Title - Sujet Cell Modifications,Bldg B4,Dor.Pen	
Solicitation No. - N° de l'invitation EC016-131794/A	Amendment No. - N° modif. 005
Client Reference No. - N° de référence du client R.035149.001	Date 2012-11-12
GETS Reference No. - N° de référence de SEAG PW-\$PWB-007-3147	
File No. - N° de dossier PWB-2-35079 (007)	CCC No./N° CCC - FMS No./N° VME
Solicitation Closes - L'invitation prend fin at - à 02:00 PM on - le 2012-11-15	Time Zone Fuseau horaire Atlantic Daylight Saving Time ADT
F.O.B. - F.A.B. Plant-Usine: <input type="checkbox"/> Destination: <input type="checkbox"/> Other-Autre: <input type="checkbox"/>	
Address Enquiries to: - Adresser toutes questions à: Ellis-Herring , Alison PWB	Buyer Id - Id de l'acheteur pwb007
Telephone No. - N° de téléphone (506) 636-3908 ()	FAX No. - N° de FAX (506) 636-4376
Destination - of Goods, Services, and Construction: Destination - des biens, services et construction:

Addendum 5

Public Works and Government Services Canada		Travaux publics et Services gouvernementaux Canada		Drawing title Titre du dessin CELL – STEEL BED ATTACHMENT ADDENDA		designed conçu PWGSC date NOV. 8, 2012
project RENOVATE CELLS SEGREGATION BLDG B-4 LEVEL 1 DORCHESTE

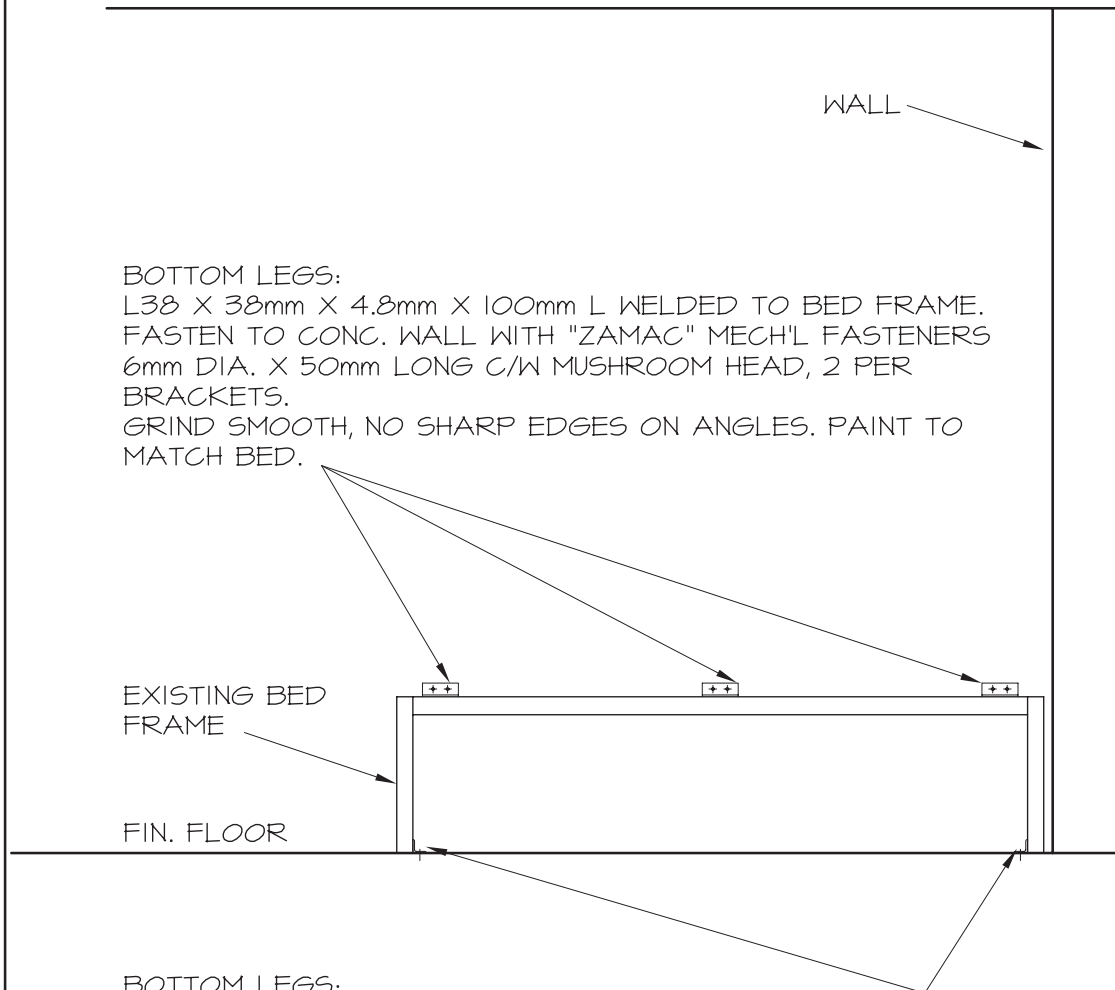
Q1: Will the existing beds and toilets need to be removed and reinstalled due to the removal and installation of the new flooring?

Q7: Are the cell beds to be removed prior to the installation of the new flooring?

NOTE,
EXISTING BED TO BE REMOVED FOR NEW
FLOOR TILE INSTALLATION. REINSTALL
AS PER INFO BELOW.

A1: Toilets to remain, bed will have to be removed and reinstalled. See SK-1.

A7: Yes, see SK-1
